Frequently Asked Questions Concerning Precast Manufacturing for the TDOT Projects

CATCH BASIN STANDARD DRAWINGS QUESTIONS

TYPE "U" CONCRETE HEADWALL DETAILS FOR D-PE-3B

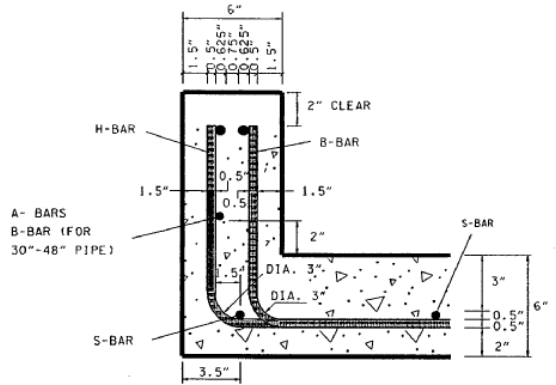
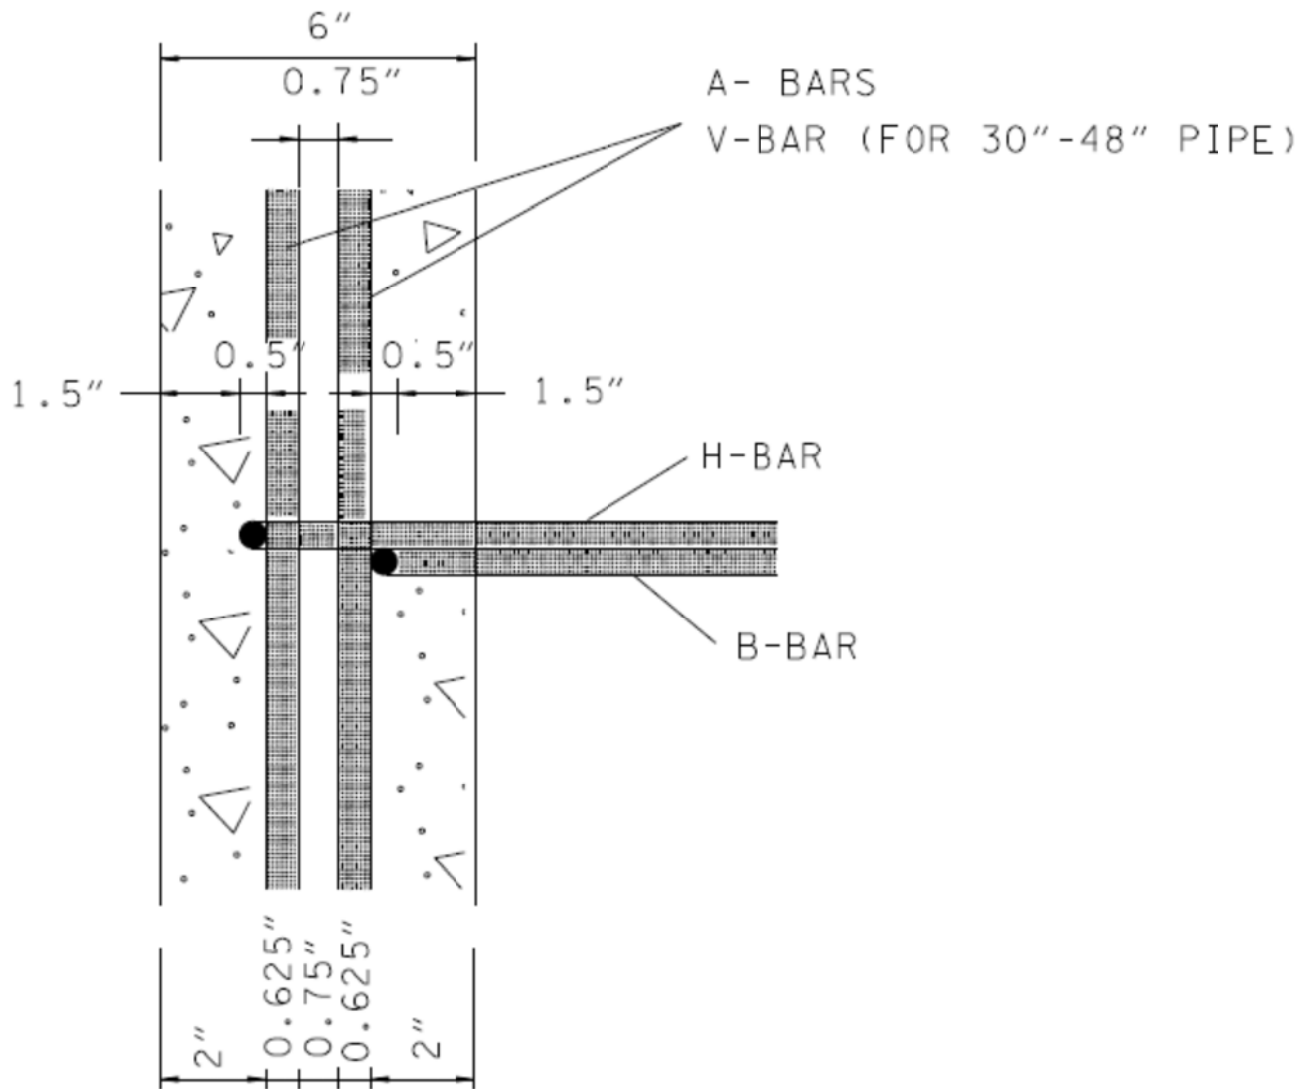
Where is the outer most S400 bar located relative to the outside edge of the wing wall?

What is the spacing of the S400 bars for the bottom slab of the pipe headwall structures?

How are the two S400 bars to be placed under the wing wall where the "bill of steel" does not correspond to the number of bars that are needed for the slab?

The outer most S400 bar is located 3.5" from the outside edge. See the elevation view.

The S400 bars should be equally spaced, but under no circumstance shall the bar spacing exceed 12 inches. The required quantity of S400 bars are shown on the Bill of Steel for the different pipe sizes

The reinforcement label arrows on plan view indicate that two S400 bars are required under the wing walls. The label should have *pointed* to the outside bar only. The number of bars required for the bottom slab is listed in the bill of steel correctly. The D-PE-Series standard drawings will be revised to remove the arrow indicating that a second bar may be required under the wall. S400 bars shall be equally spaced across the bottom slab.

CONCRETE CATCH BASIN DETAILS FOR D-CB-12LP

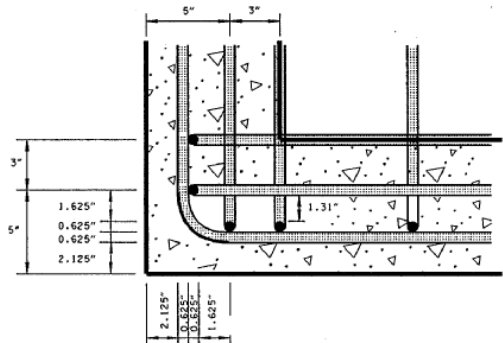
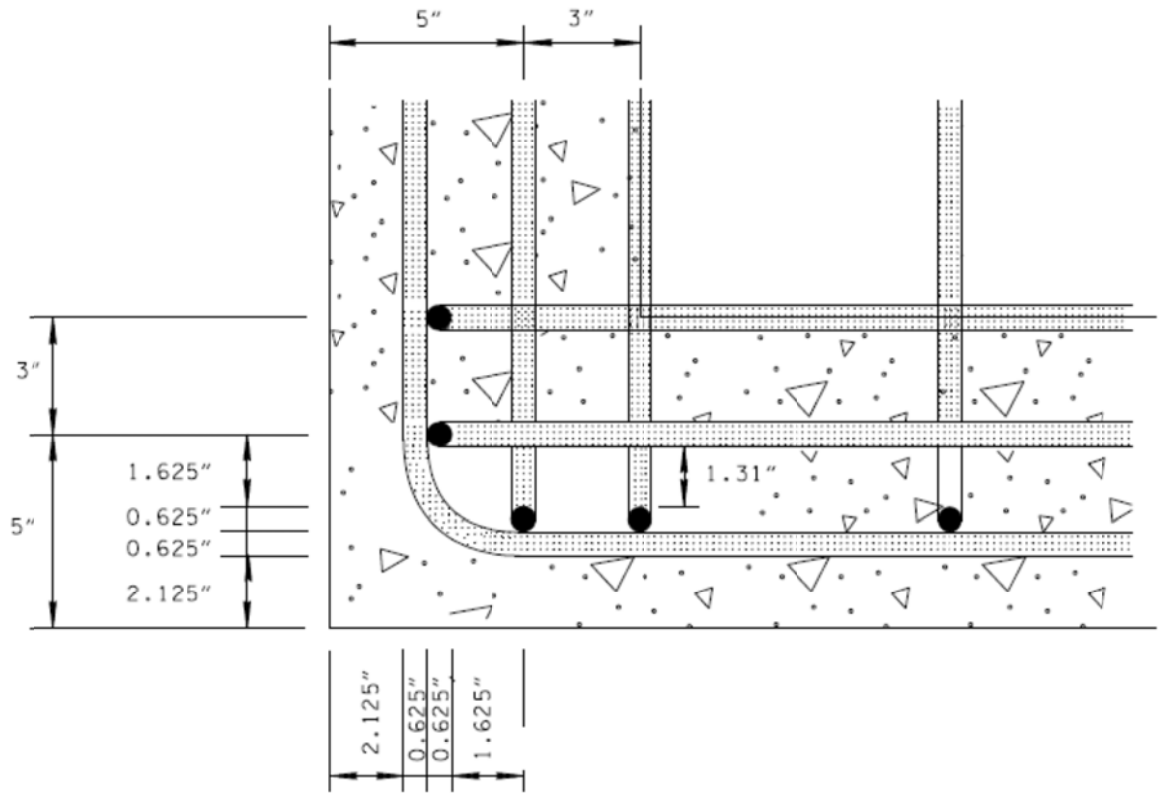
How should the reinforcing bars be bent and placed on the corners where the standard drawing shows 90 degree turn?

The standard drawings show the reinforcement members in a simple form. They are not shown to any scale or proportion. Also, reinforcement thicknesses and bending radiuses are not currently detailed for clarity. *Therefore the catch basin plan views are showing a dot for two bars meeting at the corner 1.675" apart. See the catch basin detail.*
